HARRY E. COLE & SON

October 31, 2022

Re: AA Denorfia Building & Development
570 Meriden Waterbury Turnpike (SP#1844; SPU#666)
HEC #2235

Harry E. Cole & Son (HEC) has reviewed your checklist dated October 26, 2022 and offers this formal response

Pipe Between A4 and A5 at Endwall

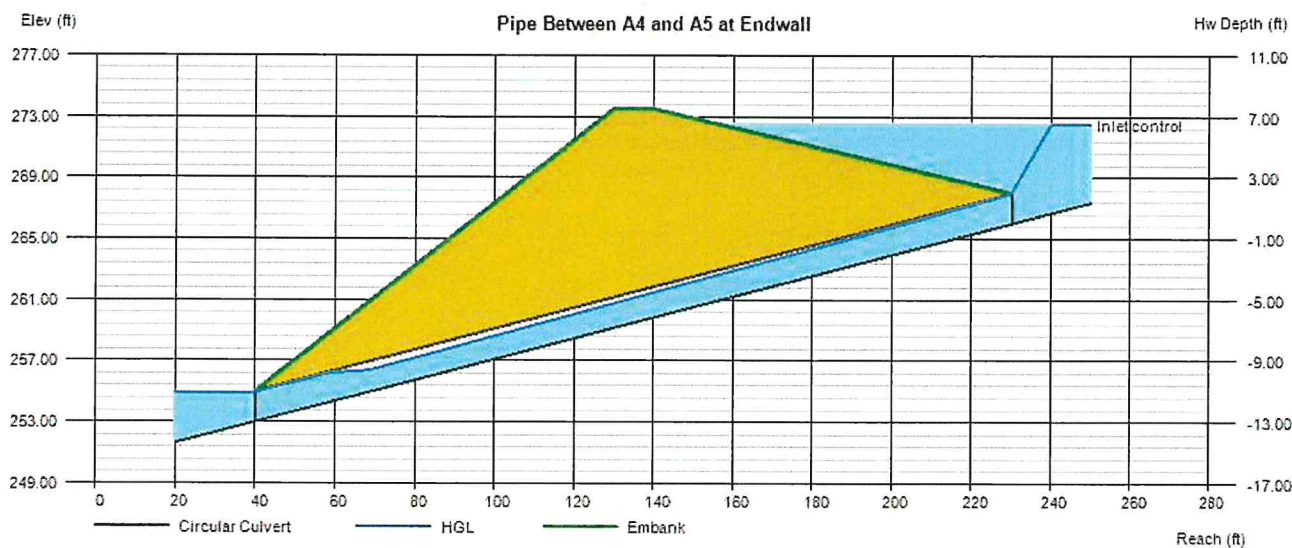
26. The proposed swale from the Hillcrest 24" discharge to the DG endwall is 5-6%. Does the swale need to be reinforced? What is the capacity of this swale?

Response: The swale directs flows a very short distance to a settling depression with a minimal bottom slope (0.25%); which is intended to dissipate the velocity of the flows prior to stormwater entering the DG endwall. This depression is approximately 3.5 feet deep and while it is designed to channel the flows from the outlet of the pond to the endwall its flat nature will also act as an energy dissipator. Modeling of the swale indicates a total capacity of 176 CFS. The anticipated flows from the uphill pond are

approximately 36 CFS during the 100-year storm which will result in the swale having approximately 1.75 feet of water. Attached is a report indicating the design criteria and capacity of the entire swale and pipe.
